**LEBANON PLANNING BOARD
DECEMBER 9, 2024 - 6:30 PM
COUNCIL CHAMBERS, CITY HALL OR
REMOTE VIA VIRTUAL PLATFORM
LEBANONNH.GOV/LIVE**

Staff Memorandum – PB2024-22-SPRCUP – *con't from 11/12/24*

Site Plan Review and CUP for a proposed 474-unit multi-family PURD, and a CUP to allow an increase in the maximum permitted building height from 45 ft. to 55 ft.

- ▶ Plan set titled “The Brickyard Residential Development,” dated May 10, 2024, latest issue December 4, 2024, prepared by VHB, EV Project: 52933.00 (53 sheets plus cover sheet)

Open Space Plan

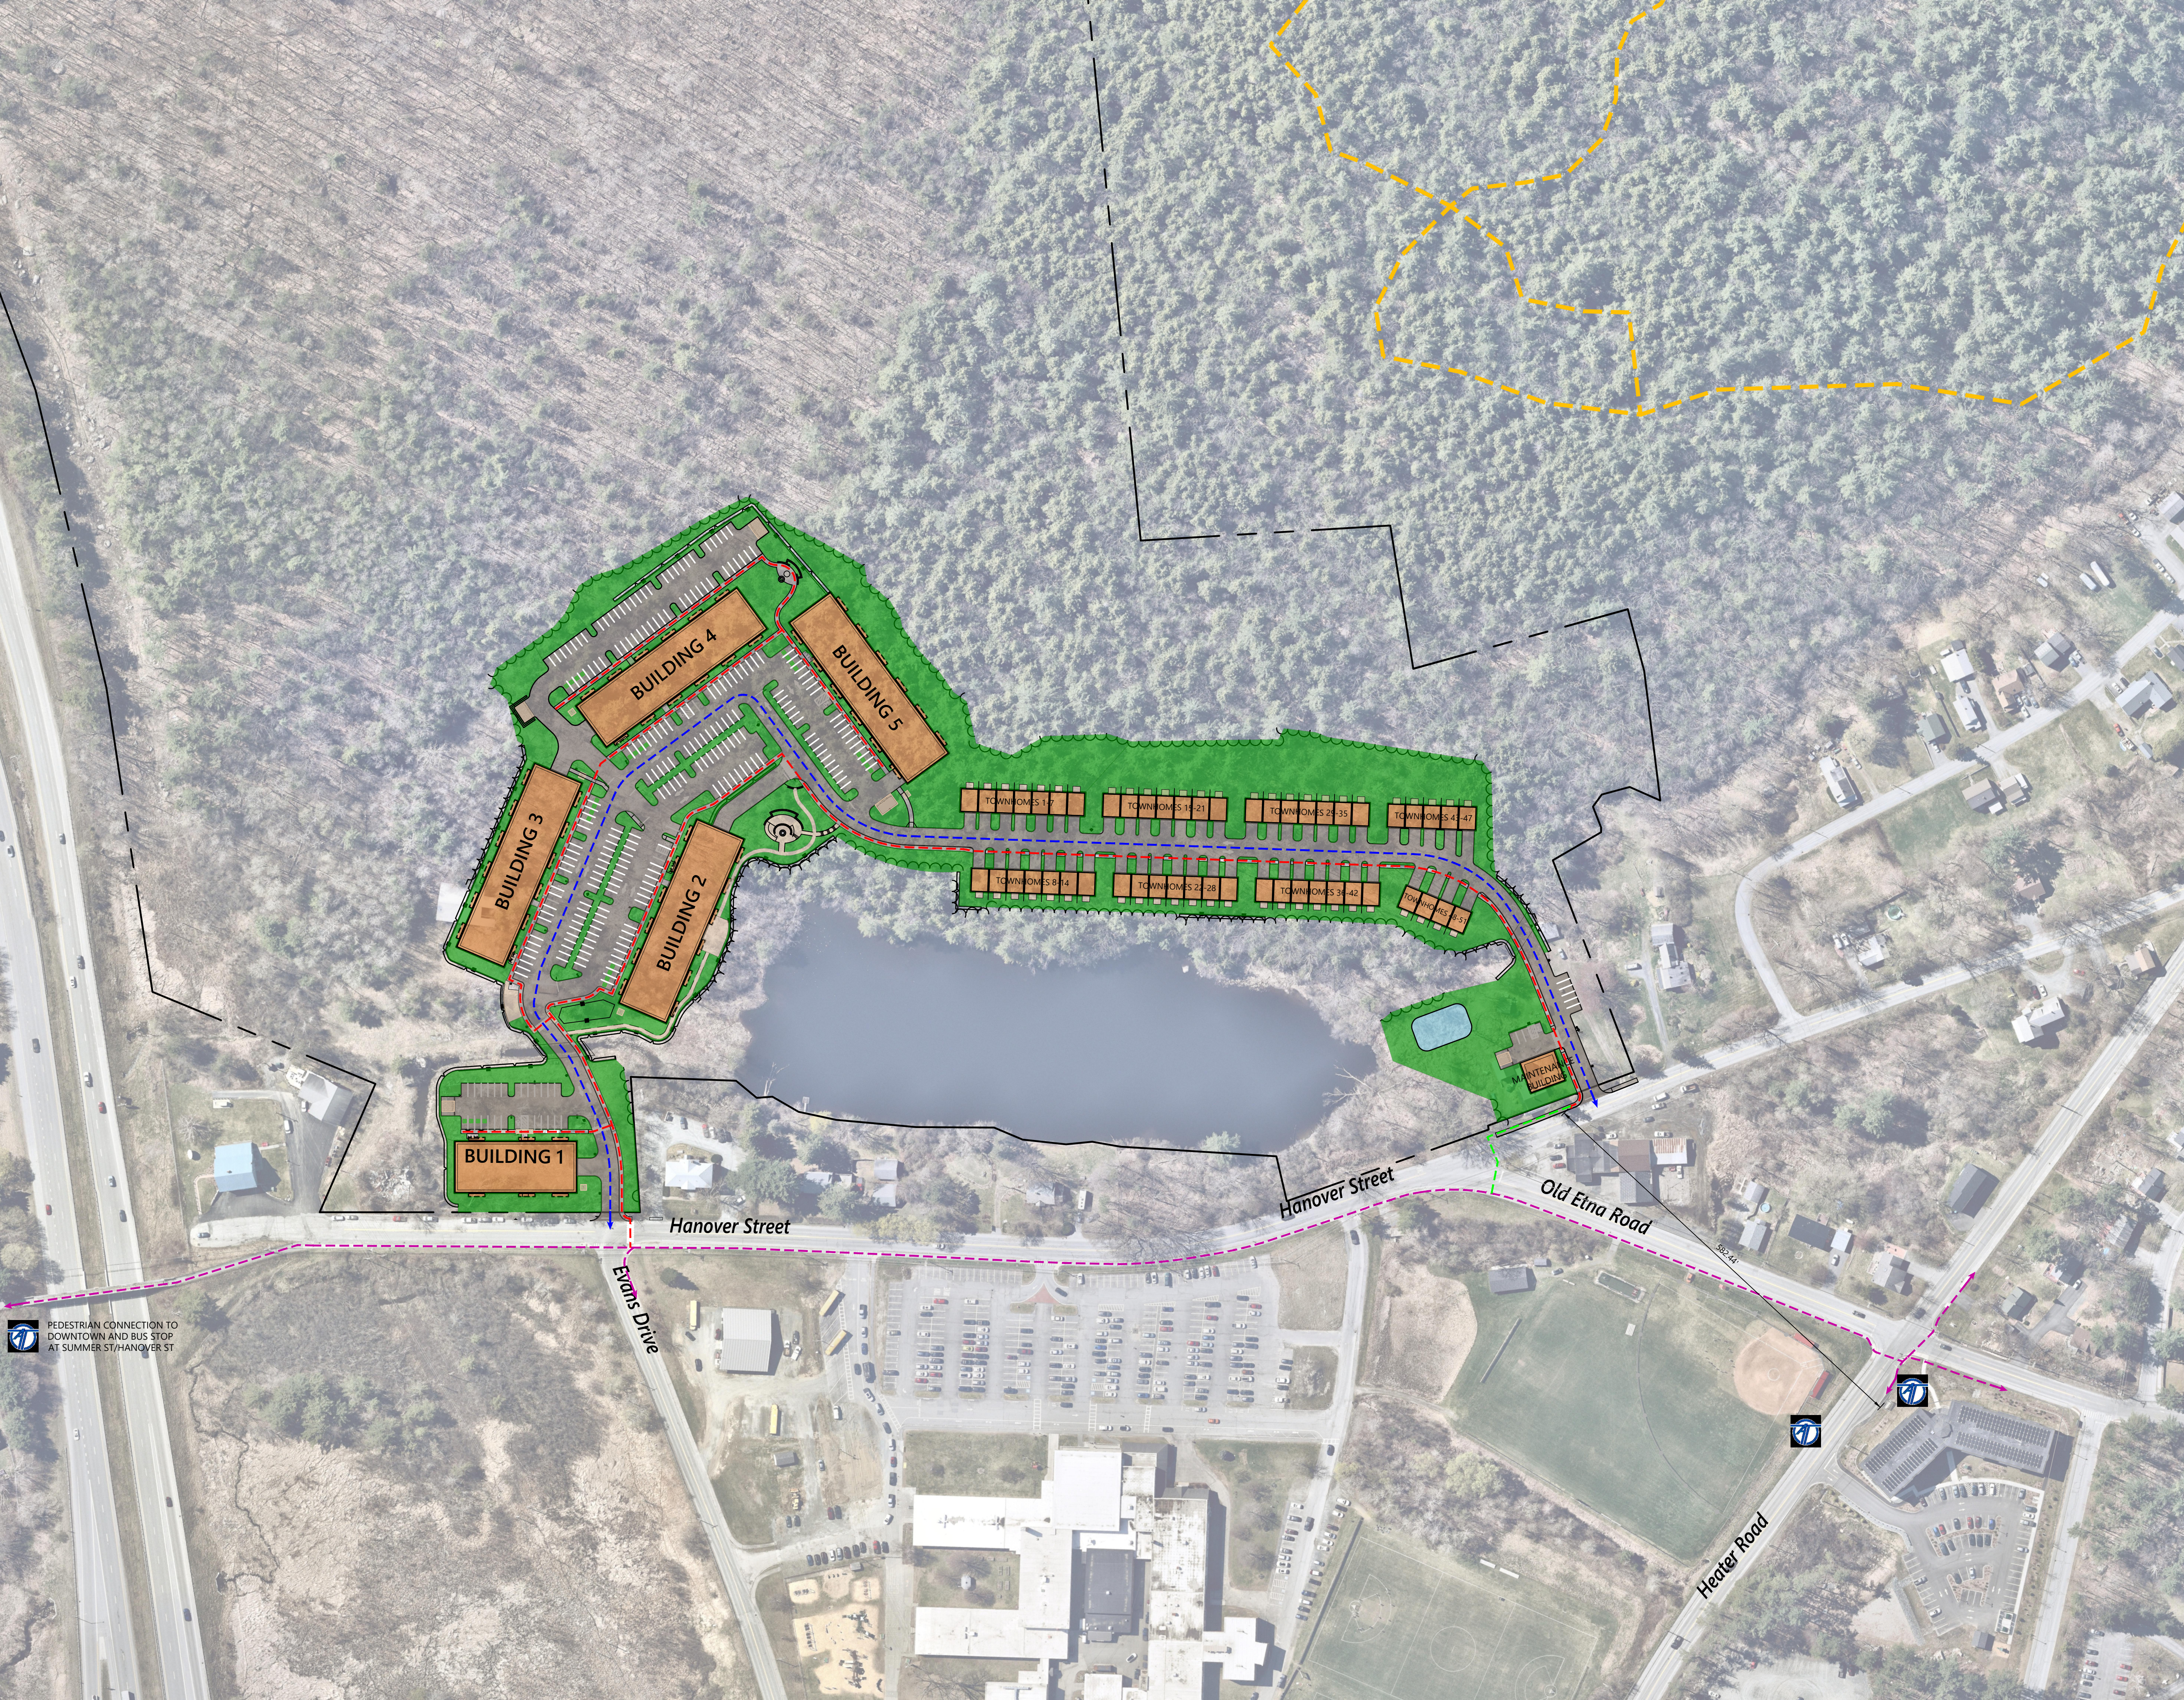
- The second asterisk applies to both the R-1 and the R-O-1
- k. Open Space Calculations table – identify the amount of open space to be provided
23. Sheet 1 (C1.0)

C1.4

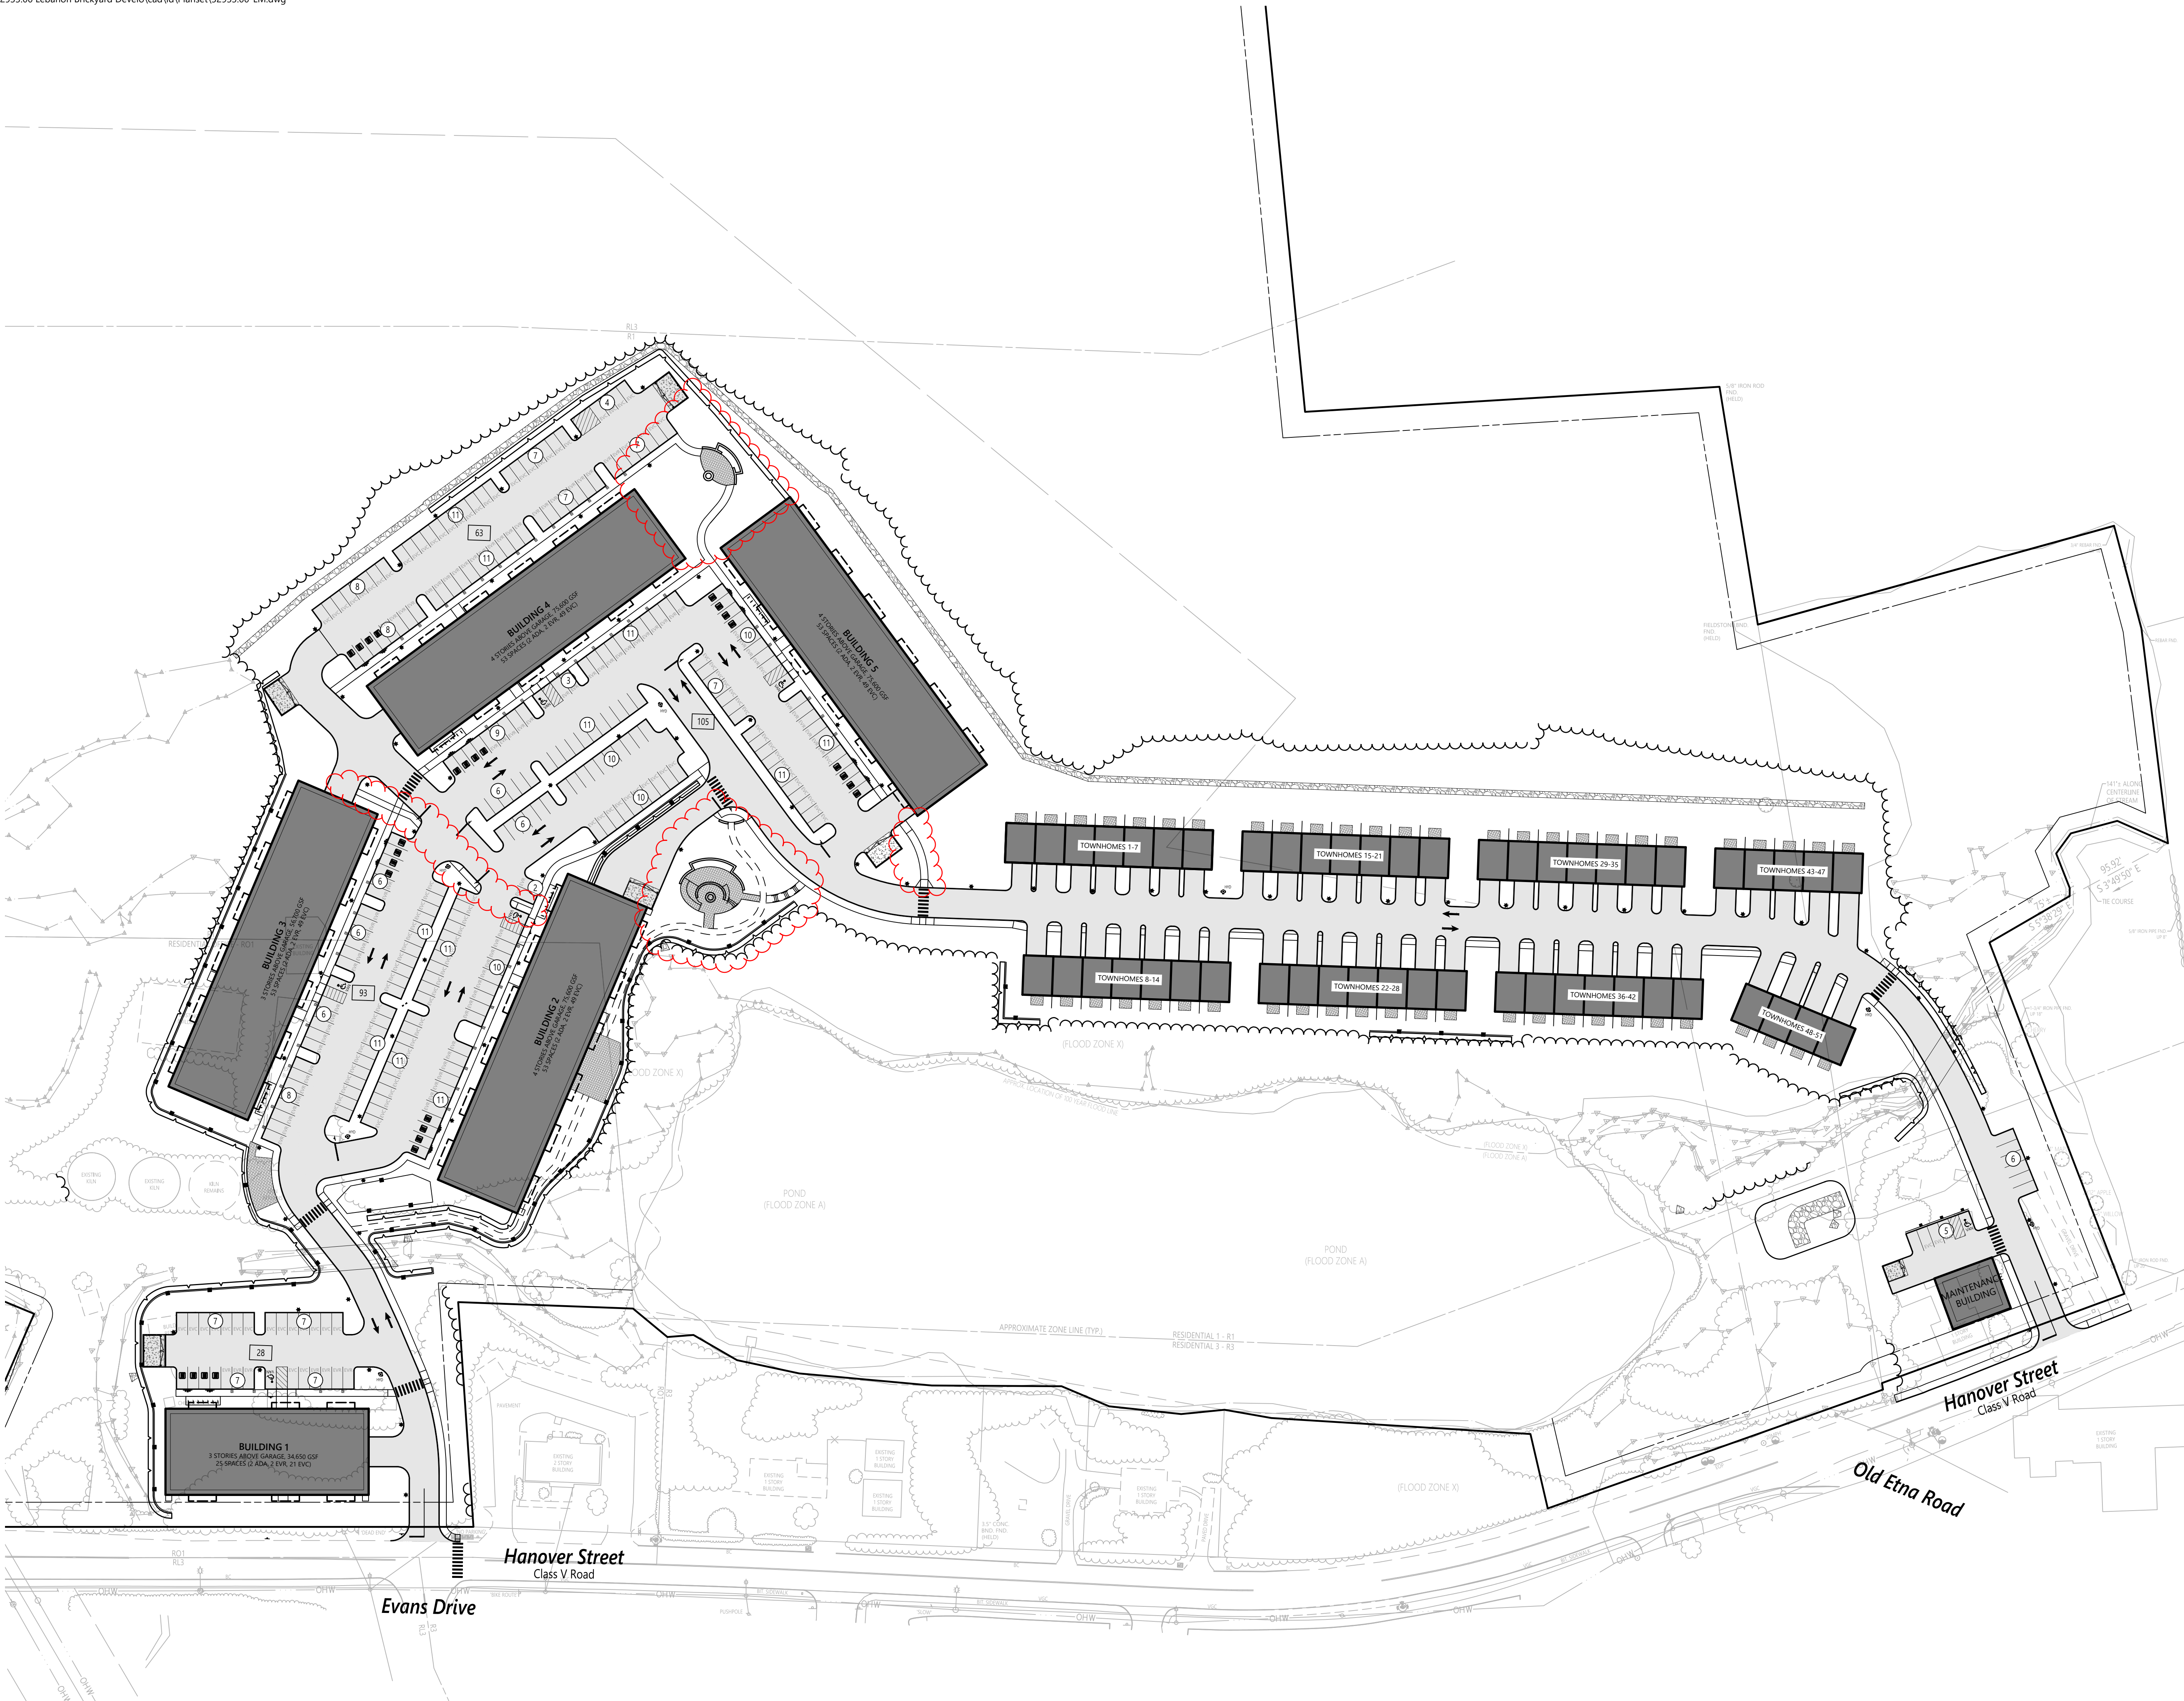
26. Sheet 5 (C1.4)
- a. Please remove unnecessary layers including existing conditions. Please depict only proposed above-ground conditions.
 - b. Move EV notes to Sheets C2.1-3

C2.1

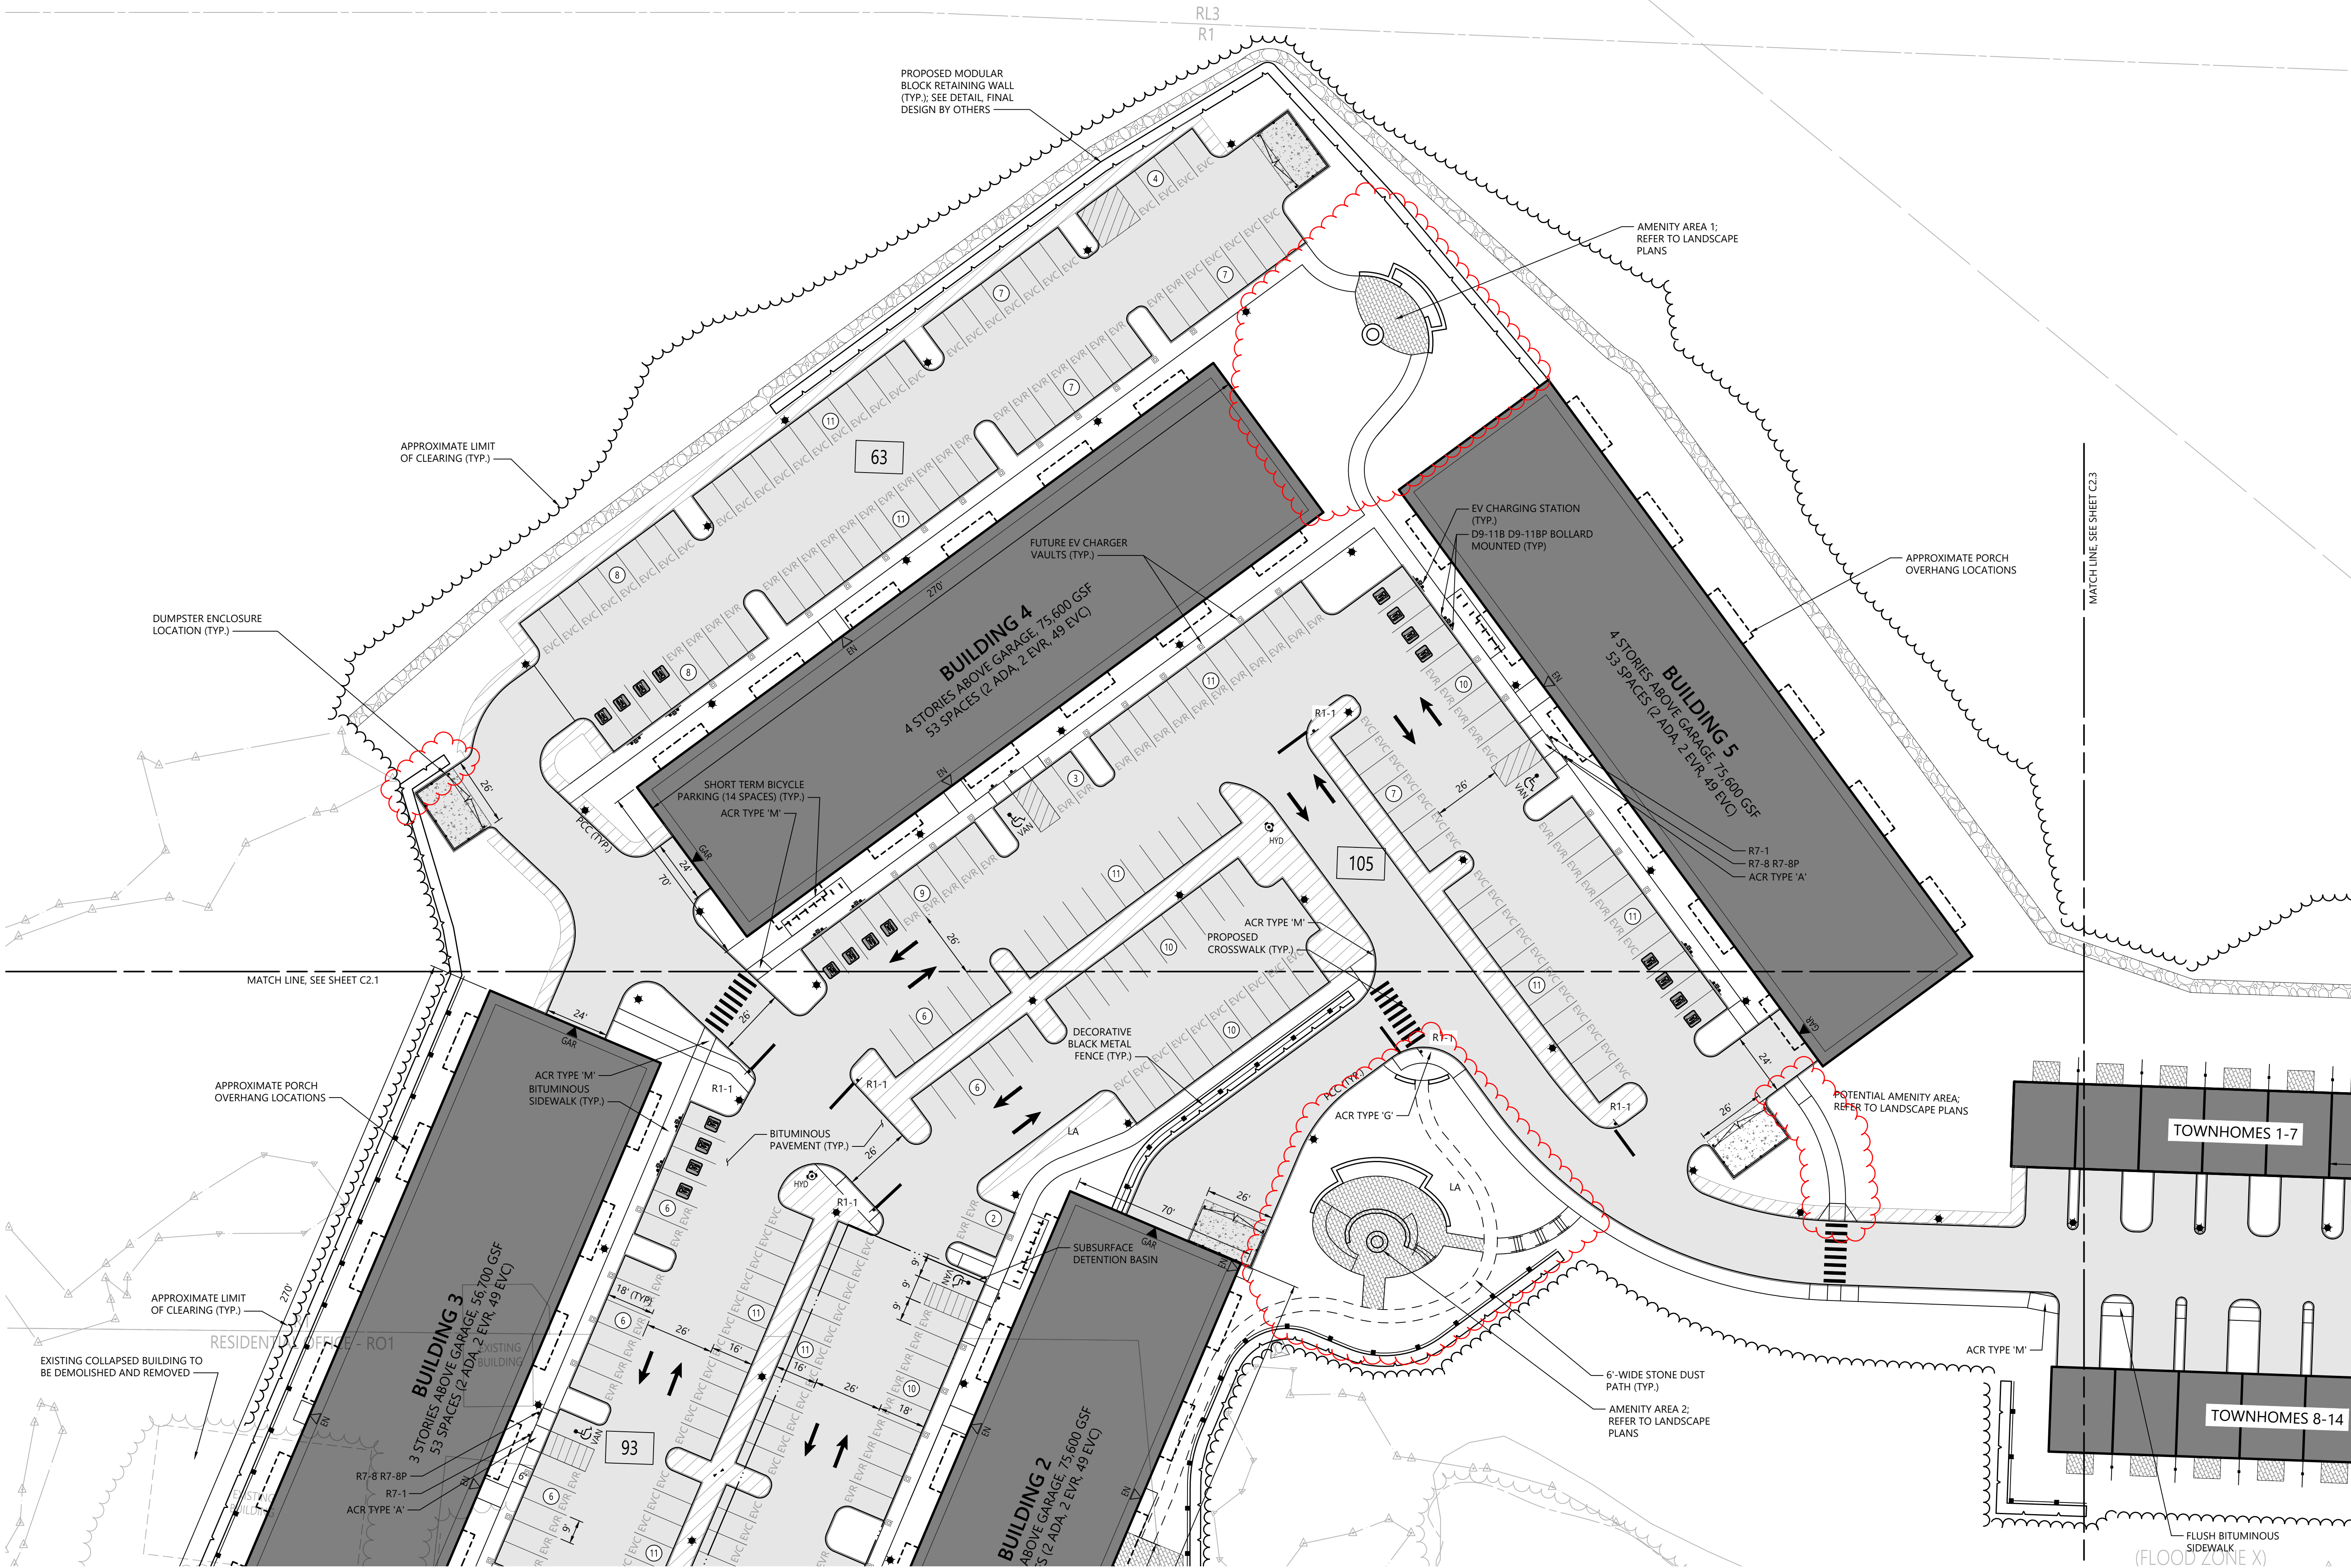
- b. Identification of suitable on-site seasonal snow storage areas [Section 5.1.E (19)].
7. Sheets C2.1 through C2.3 graphically depict a series of planned dumpster enclosure installations. Sheet C7.2 provides details of dumpster pad and enclosure construction, which refer the reader to the "plan" for dimensions. We recommend the expansion of Sheets C2.1 through C2.3 to specify the referenced dimensions.

- required sidewalks along Hanover Street portion of property
 - crosswalk at northern driveway entrance
27. Sheet 7 (C2.1)
- a. **The plat is very difficult to read. Please remove unnecessary layers including existing conditions, and provide additional labels to identify what’s proposed**
